STATE OF NORTH CAROLINA
DEPARTMENT OF TRANSPORTATION

Subject: **Addendum to Application for Section 404 Nationwide Permit 14, Section 401 Water Quality Certification, and Randleman Watershed Buffer Authorization** for the proposed widening of West Market Street (SR 1008) from Bunker Hill Drive (SR 2007) to NC 68 in Guilford County, Federal Aid Project No. STP-1008(9); Division 7; TIP No. R-2611

Reference: R-2611 NW14 Permit and WQC 3820 Application, November 30, 2010

PROJECT REFERENCE NO.		SHEET NO.	
R-2611		6	
RAW SHEET NO.			
ROADWAY DESIGN ENGINEER		HYDRAULICS ENGINEER	
INCOMPLETE PLANS DO NOT USE FOR A/W ACQUISITION PRELIMINARY PLANS DO NOT USE FOR CONSTRUCTION

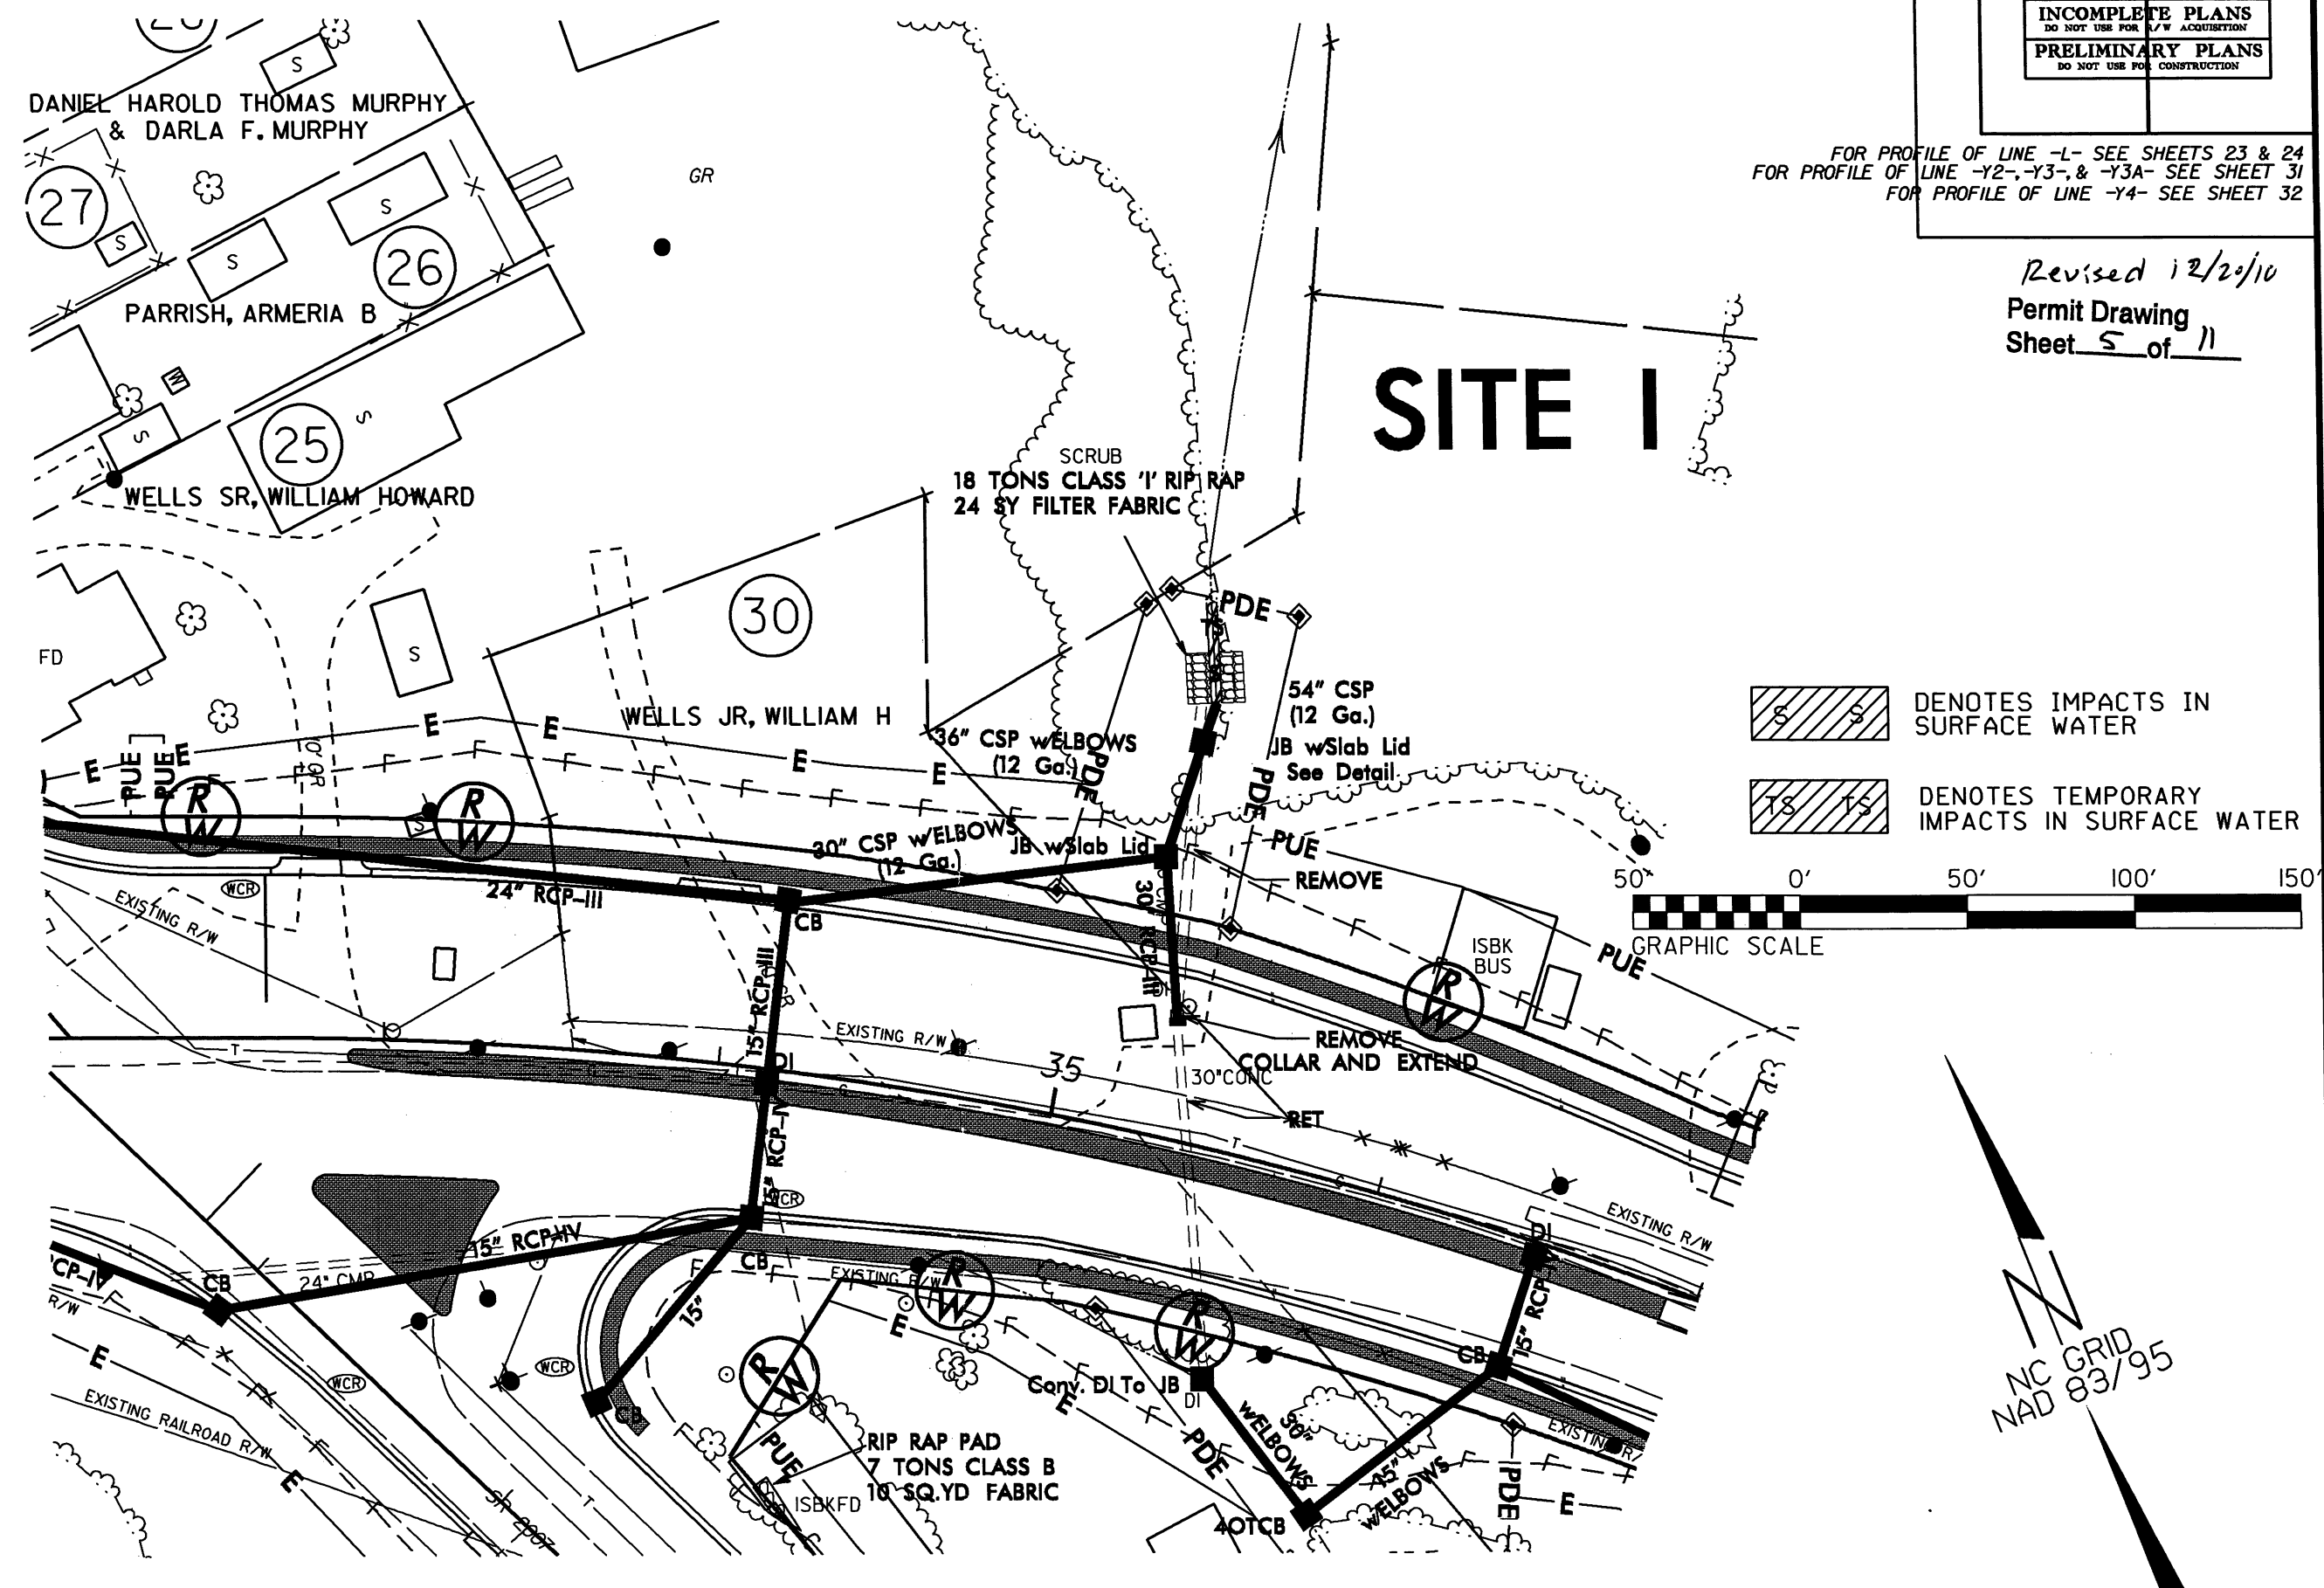
A junction box was added near the outlet at Permit Drawing Site 1 to reduce velocity and prevent erosion. This change is shown on Permit Drawing Sheets 3, 4, 5 of 11 and Roadway Plan Sheet 6. No changes have been made to jurisdictional impacts as a result of the junction box at this location.

Permit Drawing
Sheet 6 of 11

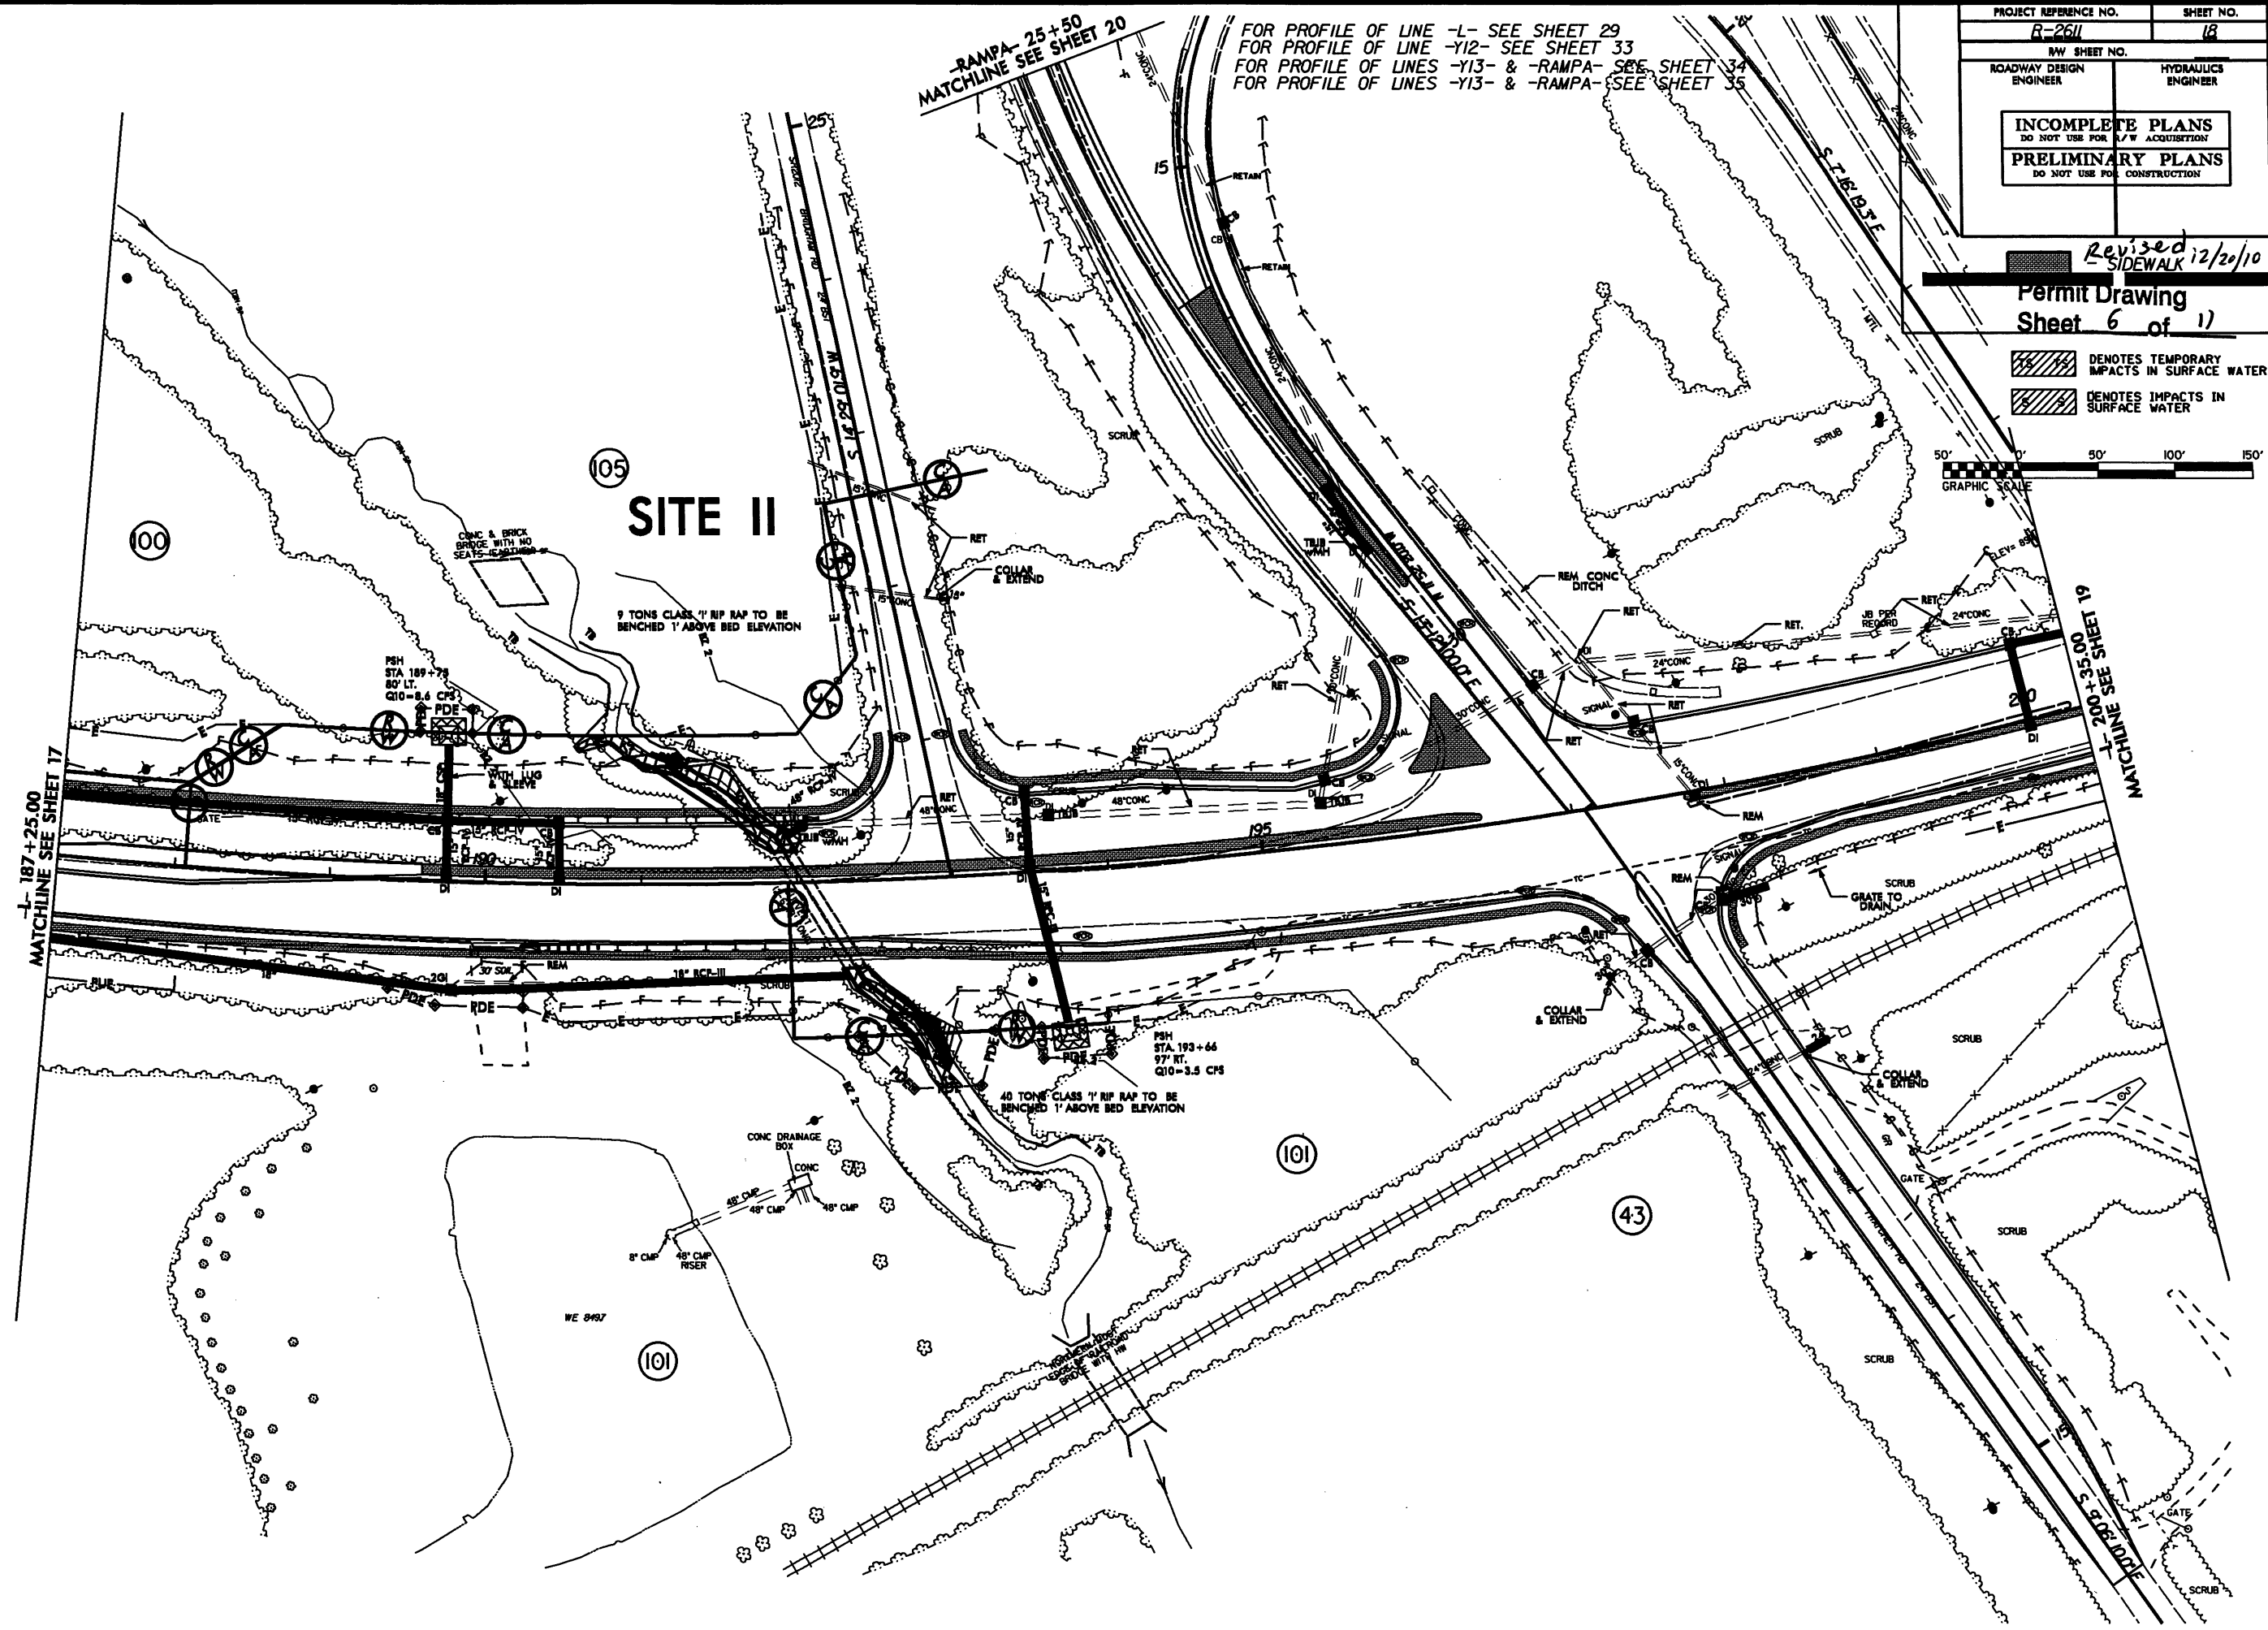
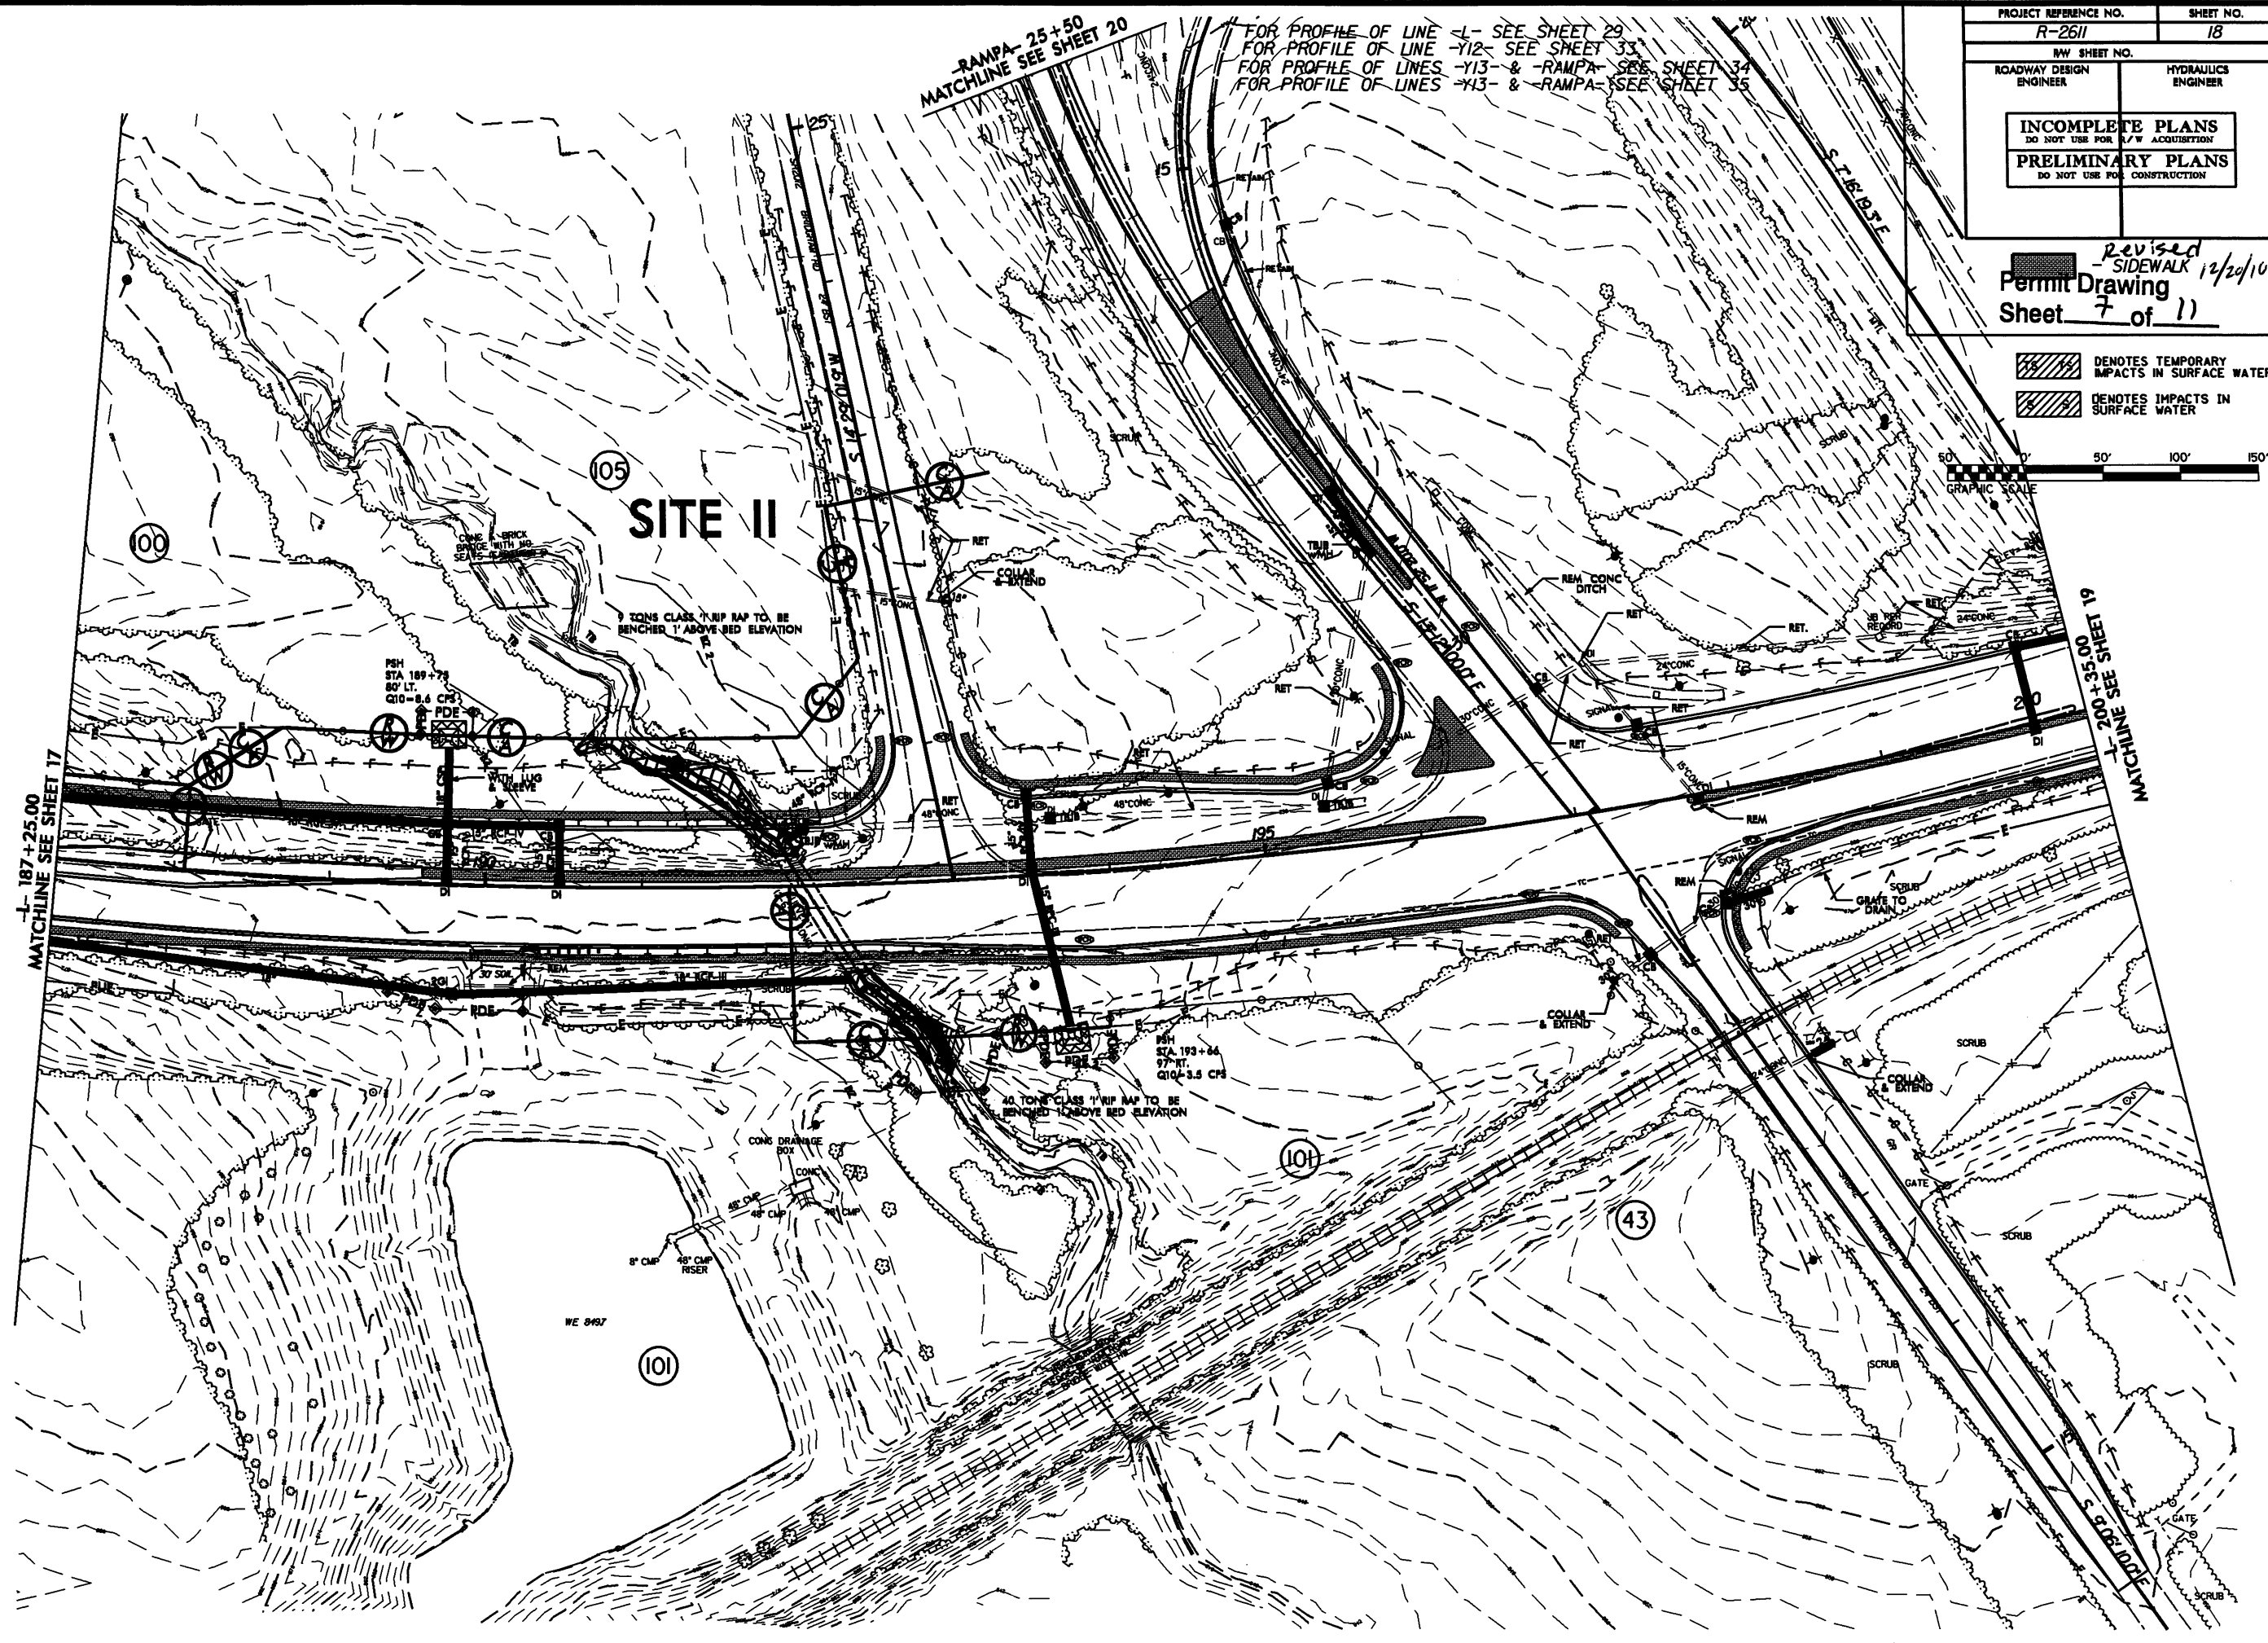
Rip rap has been placed in front of the high water culvert channel to function as a sill at Permit Drawing Site 2 (UT to East Fork of Deep River). This has caused the total permanent stream impacts to increase by 6 feet, while total temporary stream impacts have decreased by 6 feet. Total stream impacts requiring mitigation are now 200 feet. Total temporary stream impacts are now 49 feet. These changes are shown on Permit Drawing Sheets 6, 7, 8, 11 of 11 and Roadway Plan Sheet 18.
